EQUIPMENT TITLE : CHEMICAL INJECTION PACKAGE (OIL PRODUCTION) – WAX INHIBITOR

Purchase Order No	Doc Type Code	Seq. No	Rev.	DATE
168397 – 100 – PO – 3366 – MC2 – 007			Z3	17/03/22

Project: NEXEN PETROLEUM UK LTD
GOLDEN EAGLE AREA DEVELOPMENT
CHEMICAL INJECTION PACKAGE

Drawing Title: P&I DIAGRAM – WAX INHIBITOR
PACKAGE X-5101 OIL PRODUCTION

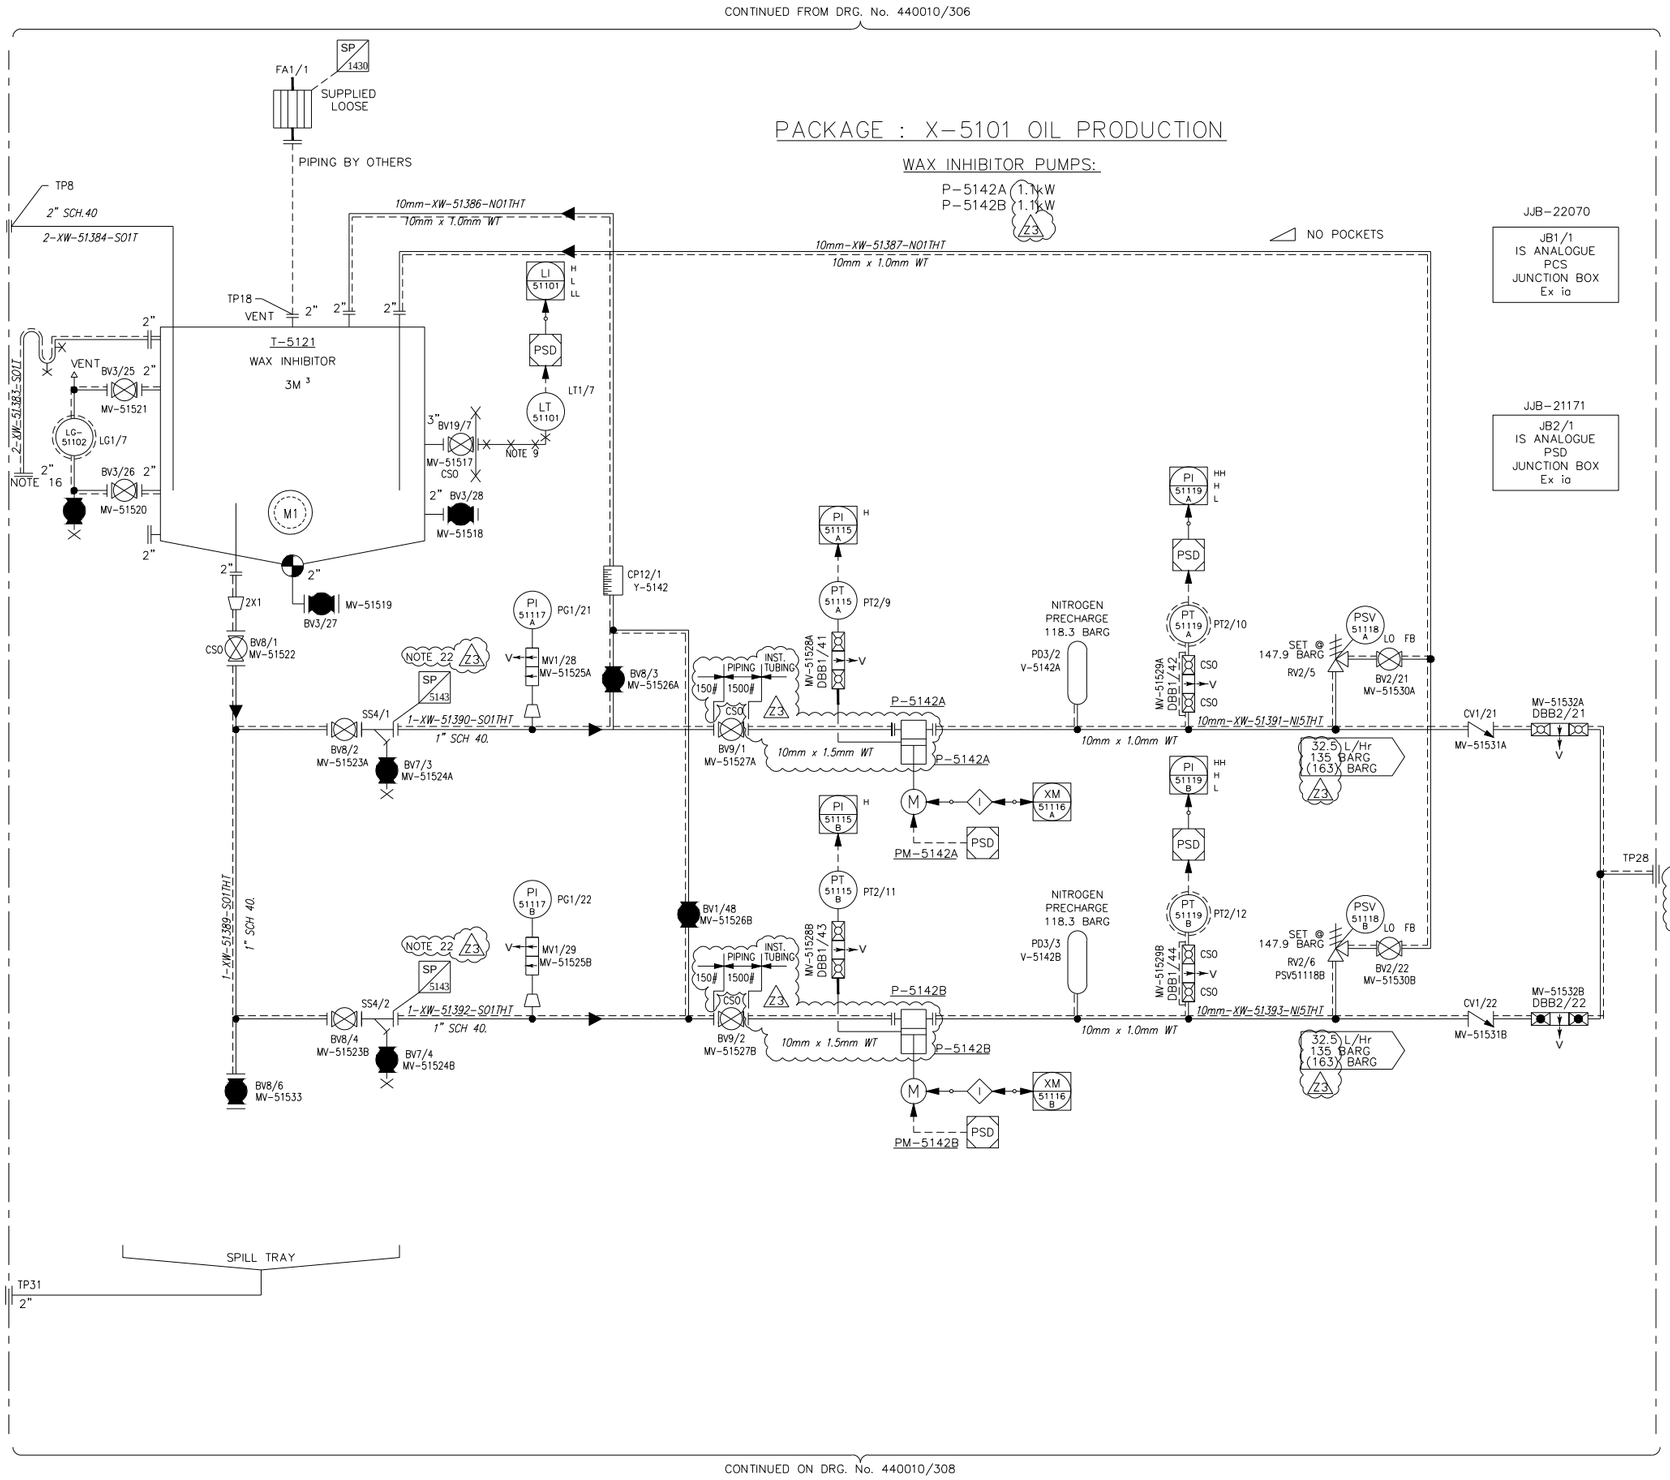
22. INTERNAL MESH SCREEN SIZE OF Y-TYPE STRAINER (SP-5143) HAS BEEN CHANGED FROM 100 MICRON MESH TO 60 MICRON MESH AS PER GMOC389.
